World Forum for Harmonization of Vehicle Regulations

Working Party on Brakes and Running Gear

Proposal for amendments to Regulation No. 30 (Pneumatic tyres for motor vehicles and their trailers)

Submitted by the experts from the European Tyre and Rim Technical Organization *

"Annex 3

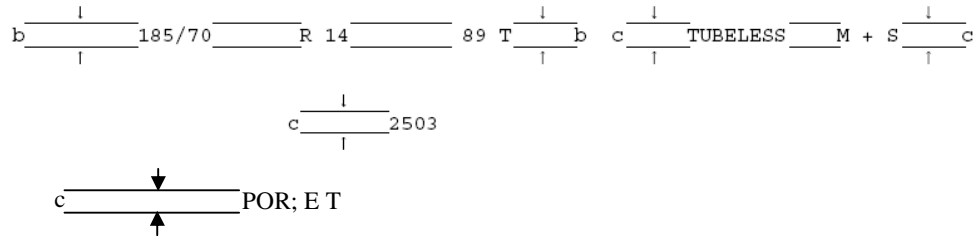
Annex 3, amend to read:

- (c) the symbols "tubeless", "reinforced", ~~and~~ "M + S", "ET" and "POR" may be at a distance from the size-designation.
